Final Independent External Peer Review Report Savannah Harbor Expansion Project Georgia and South Carolina, Fish Passage at New Savannah Bluff Lock and Dam Integrated Post-Authorization Analysis Report and Environmental Assessment

Prepared by
Battelle Memorial Institute

May 16, 2019

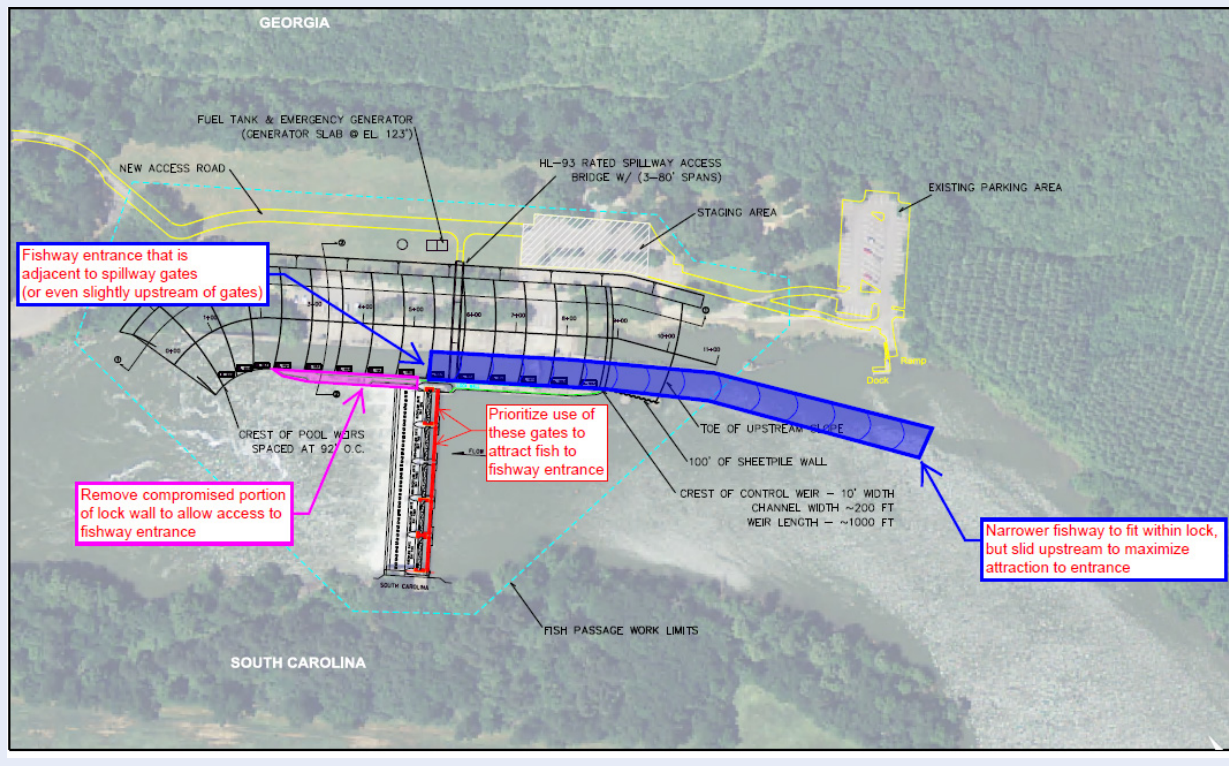
One of the key tenets of fishway design is to locate the entrance of the fishway as close as possible to the upstream barrier. This principle does not seem to have been considered in either of the two alternatives (NAA and Alternative 1-1) which retain the lock and spillway gates.

Sections 3.6.6.1 and 3.6.6.2 of the IPAAR/SEA state that the National Oceanic Atmospheric Administration believes the NAA and Alternative 1-1 will likely lead to delay of immigrating fish "...because the entrance to the fish passage structure is approximately 450 feet downstream from the existing gate system of the dam. Therefore, during high flow conditions, false attraction to the operating gates will lead immigrating fish to the dam and not the fish passage structure thereby causing a migratory delay." It is unclear why the IPAAR/SEA does not consider options that repair and retain spillway gates and establish a fishway layout that locates the fishway entrance adjacent to the spillway gates to mitigate the concern for false attraction and delay. This option could be achieved by removing the compromised portion of the lock wall downstream of the spillway gates, as shown in the following illustration revised from the Concept Design Drawing for Alternative 1-1 (Appendix A of the IPAAR/SEA, Attachment 1):

1. Consider analyzing the following alternatives in the IPAAR/SEA, or explain why such alternatives were not considered:
 - a. Alternatives that retain the spillway gates and locate the entrance of the fishway as close as possible to the gates.
 - b. Alternatives that remove the compromised portion of the lock wall downstream of the spillway gates while retaining the rest of the lock and spillway gates.
 - c. Alternatives with smaller-sized fishways that could rely on the discharge from an adjacent spillway gate to provide supplemental attraction flow to draw migrating fish to the fishway entrance.
